Project: Colorado Stone Quarries-Response to Request for Additional Information (June 17, 2021)
(U.S. Army Corps of Engineers Project Number: SPK-2019-00889)

CONCEPTUAL COMPENSATORY
MITIGATION PLAN
JULY 19, 2021
SPK-2019-00889

PRIDE OF AMERICA MINE
COLORADO STONE QUARRIES
MARBLE, GUNNISON COUNTY, COLORADO

Photo 1. Red circle depicts the smooth cut marble. Blue circle depicts roughened surface.

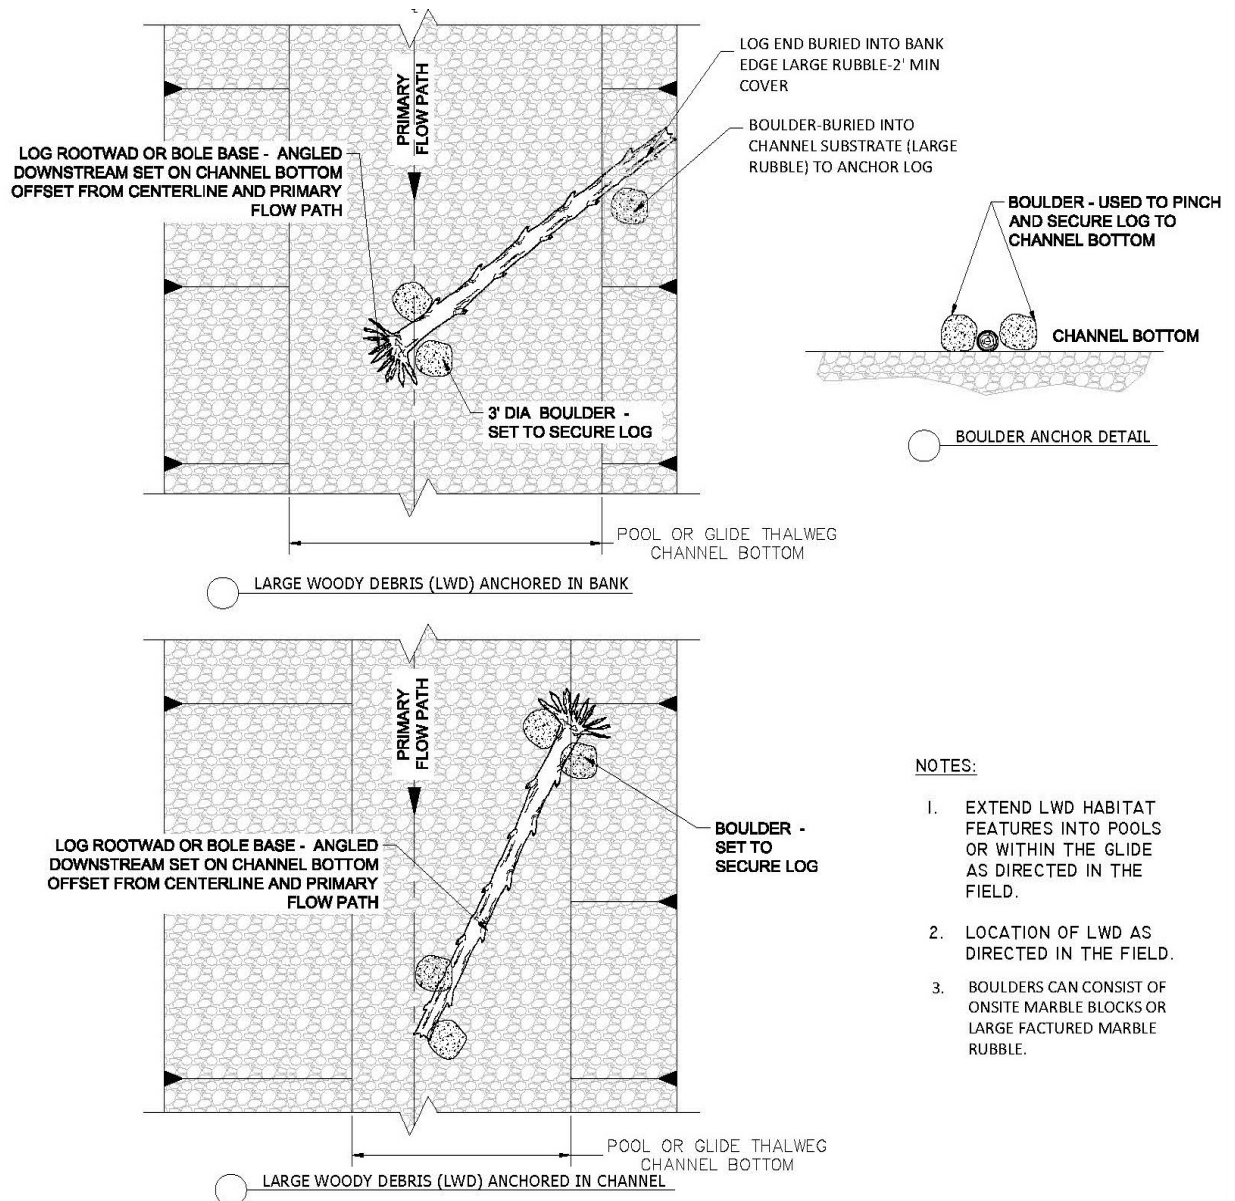
10. USACE has expressed concern of the use of smooth cut marble block rather than naturally rough surfaces within the constructed eastern channel. CSQ proposes to roughen the surface of exposed block surfaces with a drum cutter to create a more natural surface. Marble is the natural bedrock in much of this section of Yule Creek. Photo 1 provides an example of the roughening technique. The resulting roughened surface more closely mimics the natural rough surface of substrate and bedrock material in the area and will allow for greater biomass accumulation on the surface.

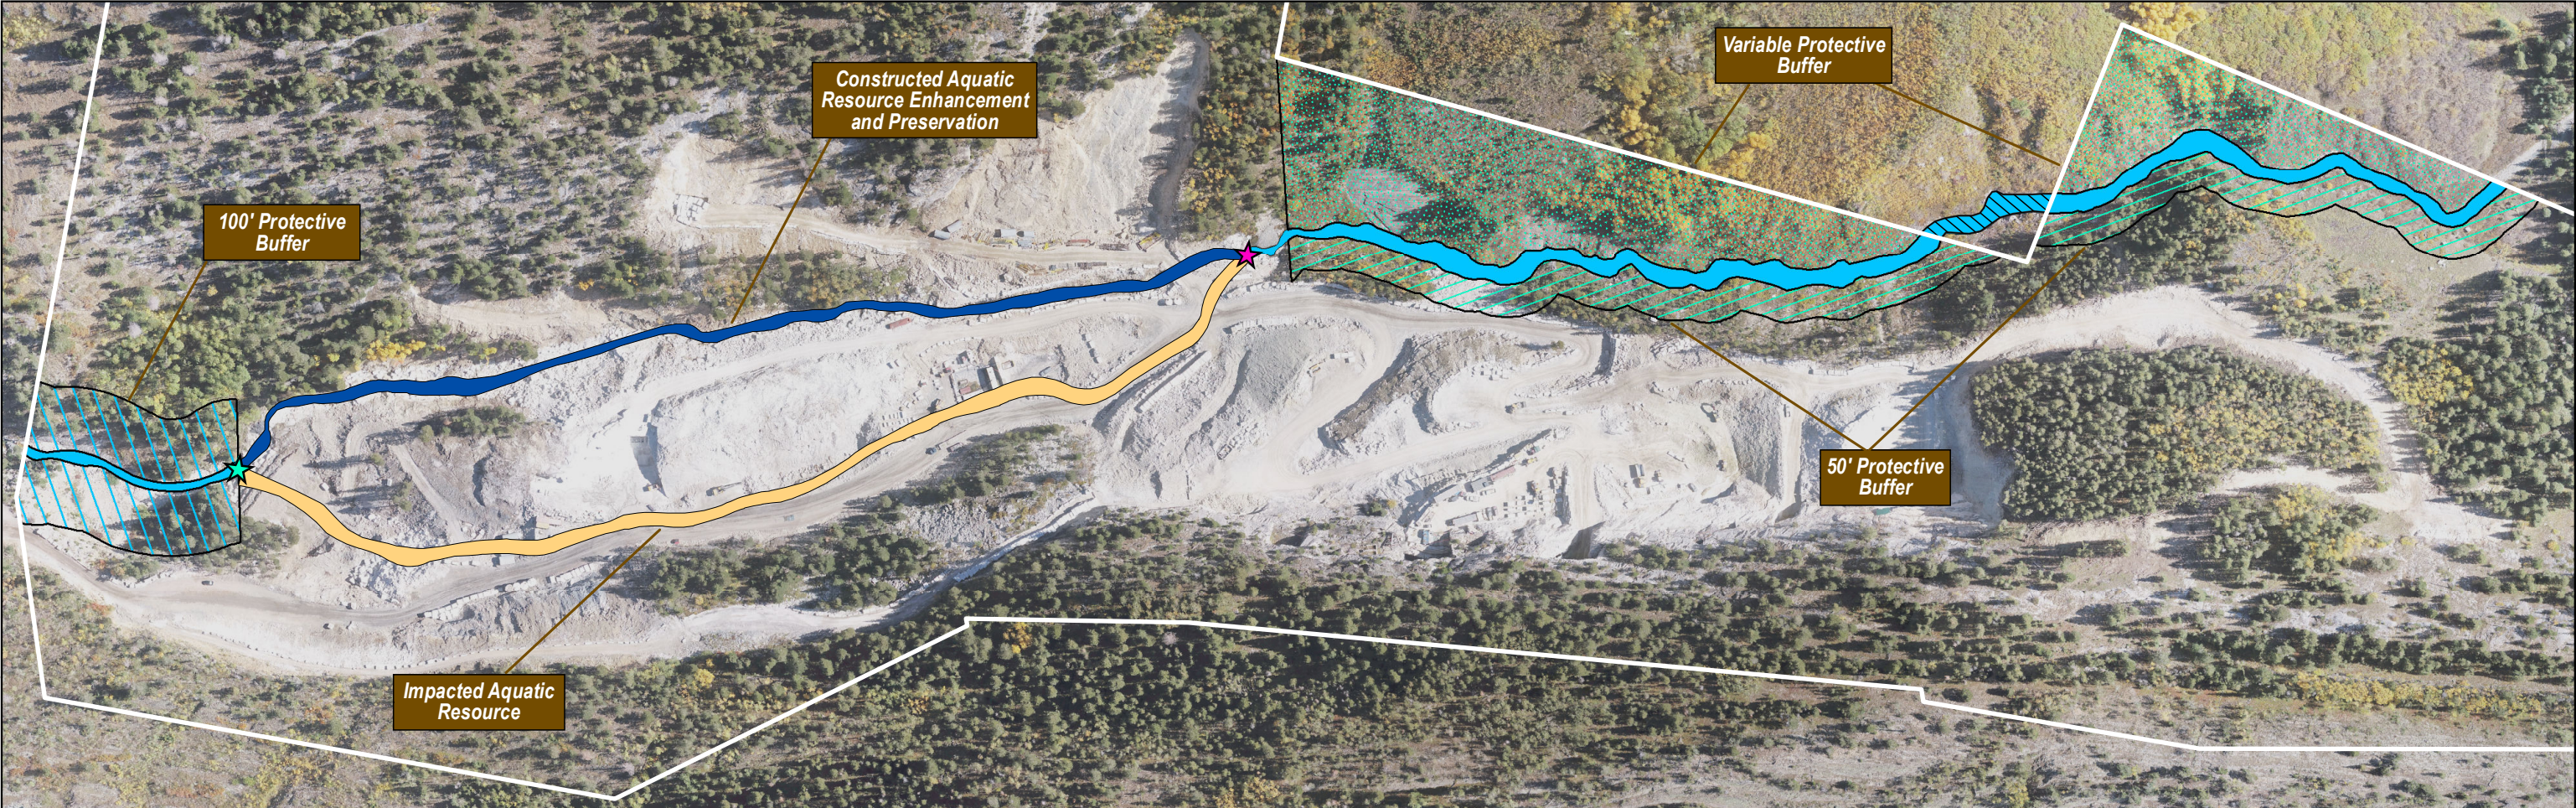
12. *Item 2d-Please revisit and specify the proposed design goals and provide specific performance standards related to the extent and cover of the woody riparian species along the banks of the eastern channel. Any changes to the proposed design goals would need to be incorporated into an updated report of the SQT assessment. Performance standards should be in accordance with the South Pacific Division Uniform Performance Standards (enclosed).*

- In order to obtain the ecological function uplift as determined per the CSQT, Riparian Extent per the 2021 Mitigation Plan shall be established along 2,600 linear feet of the Yule Creek bankfull edge covering approximately 13,000 square feet. The Plan assumes 75% linear coverage of woody riparian coverage along the bank (total length of both stream banks equals $3,378 \times .75 = 2,600'$ @ approximately 5' width or 13,000 square feet). This will be accomplished through the planting of willow stakes or nursery potted willows at approximately 3' on-center spacing. Willows are naturally occurring along the margins of the streams around bedrock and rubble in undisturbed areas of Yule Creek. Photo 2

- The performance standard and determination of success of this Riparian Extent Parameter was outlined in the ERC Yule Creek Monitoring Plan (3-22-21) (March 2021 Monitoring Plan). The target CSQT Field value has been established at 75% for Riparian Extent and Woody Vegetation Cover as determined per the Riparian Vegetation Form.

- CSQ does not need to revisit this parameter and is committed to achieving the performance standard as indicated.
- Please note that the performance standards and measurement methods have been established as part of the March 2021 Monitoring Plan and follow the specific methods of CSQT. Field data forms are included in the March 2021 Monitoring Plan. Performance Standards are defined by achieving the target field values of 92.5 functional feet as determined by CSQT.
